Category E	Repair Guidance	Ref. No. R008/09A	Page 1 of 2
Coverage <input type="checkbox"/> Distributor only <input checked="" type="checkbox"/> Please inform your dealers		Date Issued February 3, 2009	
Please convey this information to your <input type="checkbox"/> Director <input checked="" type="checkbox"/> General Manager <input checked="" type="checkbox"/> Warranty Dept. <input checked="" type="checkbox"/> Parts Dept. <input checked="" type="checkbox"/> Training Dept. <input checked="" type="checkbox"/> Field Rep.		Date Revised May 12, 2010	
Applicable Model RX-8 (FE / SE)		Applicable Countries or Specifications Worldwide

[Revised]

Note: "BEGINNING VIN & DATE OF MODIFICATION" and "REPAIR PROCEDURE" have been revised.

Subject: Coolant Warning Light Comes ON

Coolant Reservoir Tank

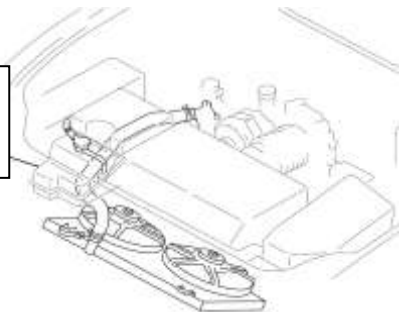
Some vehicles may experience that the coolant level warning light comes on even though the amount of coolant in the radiator and coolant reservoir tank is sufficient.

The surface of coolant level sensor float in the coolant reservoir tank is deteriorated and the float absorbs coolant and gets heavy, then sinks into coolant. As a result, the coolant level warning light comes on.

The specification of coolant level sensor float has been changed.
(Replacement part differs depends on design level of the coolant level sensor.)

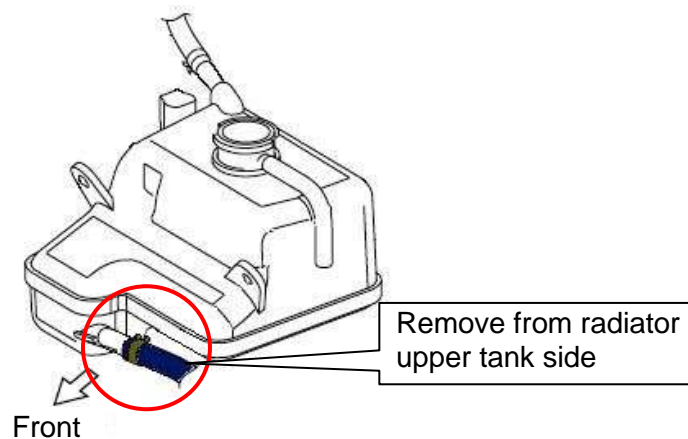
1. Remove the coolant reserve tank according to Workshop Manual "COOLANT RESERVE TANK REMOVAL/INSTALLATION"

Note: When removing the water hose shown below from the reserve tank, remove from the radiator upper tank side then remove the reserve tank side, otherwise the nipple on radiator upper tank may break.

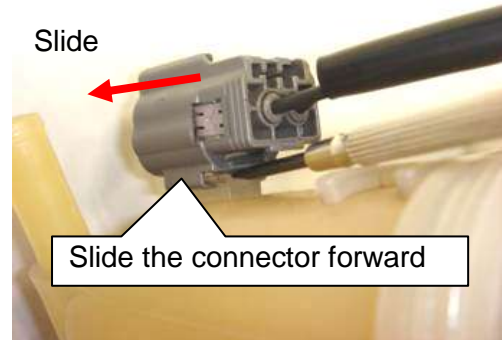
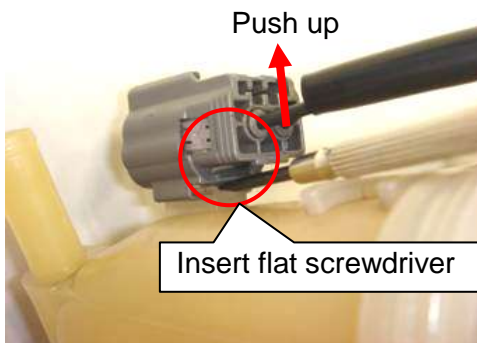
2. Replace the necessary parts according to the VIN range as shown below.

US Spec. From JM1FE***** 100000 to 157837 EC Spec. From JMZSE***** 100000 to 132988 ADR Spec. From JMOFE***** 100000 to 103558	➔	Replace the "tank with sensor"
US Spec. From JM1FE***** 157838 to 403405 EC Spec. From JMZSE***** 132989 to 300932 ADR Spec. From JMOFE***** 103559 to 300695	➔	Replace the "tank only"

- (1) Remove the cooling system cap from the coolant reserve tank. The cap will be reused.
- (2) Install a new coolant reserve tank (tank with sensor) and then attach the coolant system cap.

- (1) Remove the cooling system cap from the coolant reserve tank. The cap will be reused.

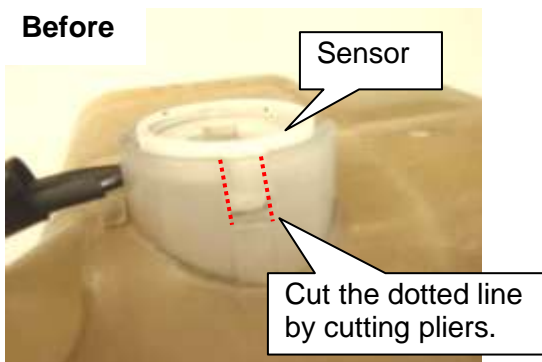
- (2) To remove the sensor connector from the tank, insert a flat screwdriver underneath the connector and push up. Then slide the connector forward.

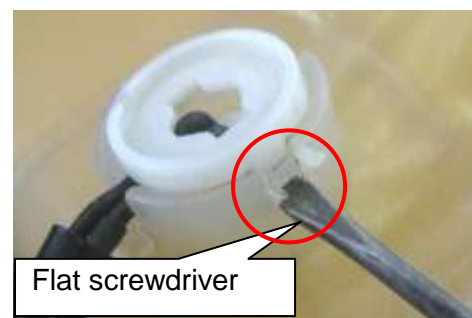
- (3) To remove the sensor from the coolant reserve tank, cut the dotted line as shown below (both sides) by using cutting pliers.

- (4) Remove the sensor from the coolant reserve tank by flat screwdriver. The sensor will be reused.
- (5) Install the sensor and attach the connector on a new coolant reserve tank.
- (6) Attach the coolant system cap.
